ATTACHMENT A – RESPONSES TO REVIEW COMMENTS

Figure 1 – Decision Tree for Waste Classification and Storage

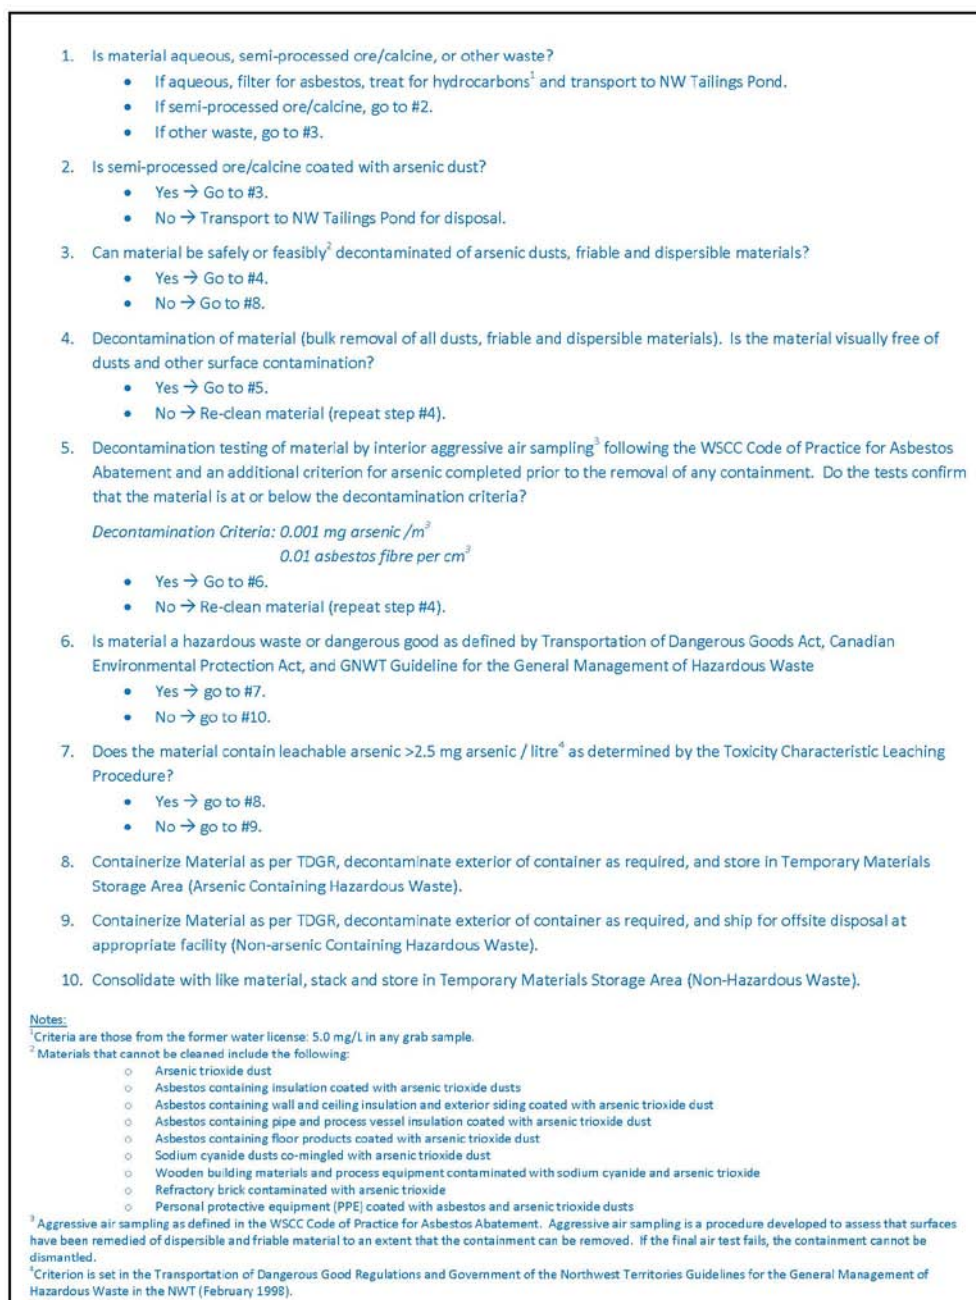
[Comment 24 – Alternatives North](#)

The Roaster Complex Deconstruction Waste Management Plan describes how wastes will be categorized and segregated but is repeated here for reference purposes. Figure 1 below displays the same information, just in a decision tree format.

All materials, whether solid or liquid, within and making up the roaster complex are considered arsenic containing prior to the start of decontamination. The decision tree is then used to classify and segregate waste.
